ALLEGRO PARMER

SP-2019-0170C

VARIANCE REQUEST

- To allow development in a Critical Water Quality Zone (LDC 25-8-261)

EXHIBIT 1 – EXISTING UNDERSIZED WATER QUALITY/DETENTION POND

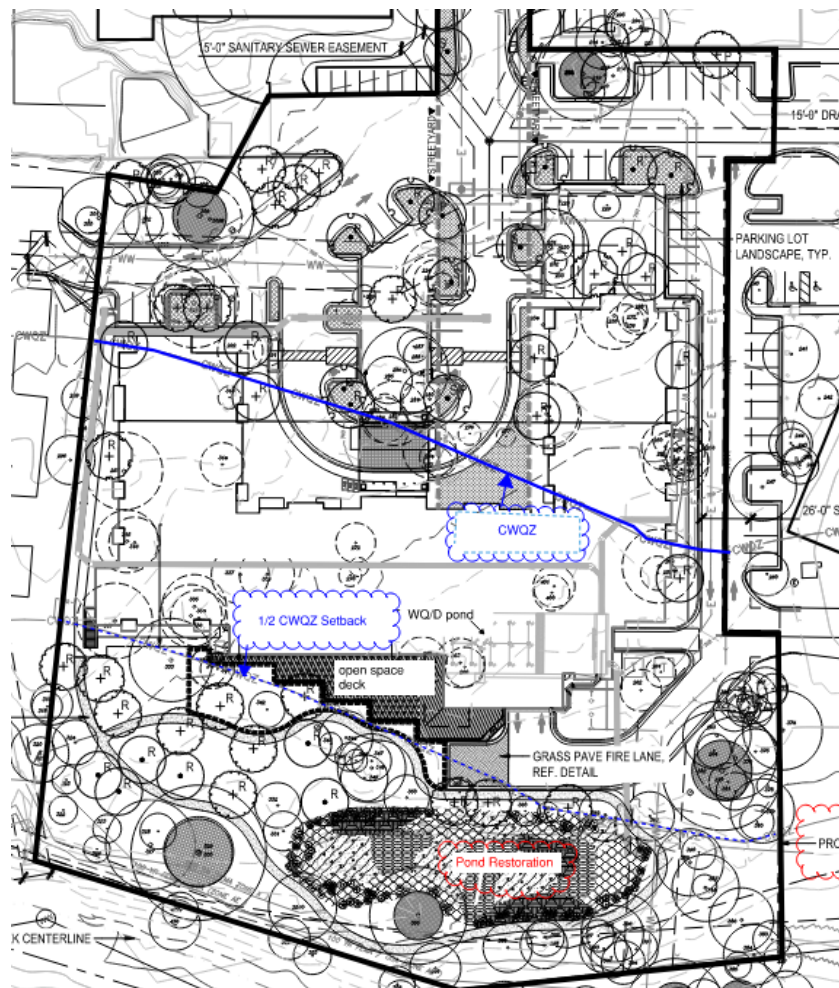
The existing water quality pond treating the pollutant load from the impervious cover of the parking lot is undersized and does not comply with current code. With this variance, not only will the pond be properly sized to treat runoff for the entire site, but also will be located further away from the creek centerline and outside of the inner half of the critical water quality zone. See Exhibit 1 on slides 14 and 15.

- 1) Fully dismantle the existing water quality and detention pond, including pond appurtenances and underdrains, and provide restoration in accordance with City Standard Specification 609.S (see following Exhibit 2, slide 16);
- 2) Clean up debris and trash along the portion of Yett Branch creek located at the southern property boundary of the commercial subdivision (see following Exhibit 3, slide 17); and
- 3) Design the fire lane turnaround within the CWQZ in accordance with ECM 1.6.7 to reduce pollutant load and impervious cover
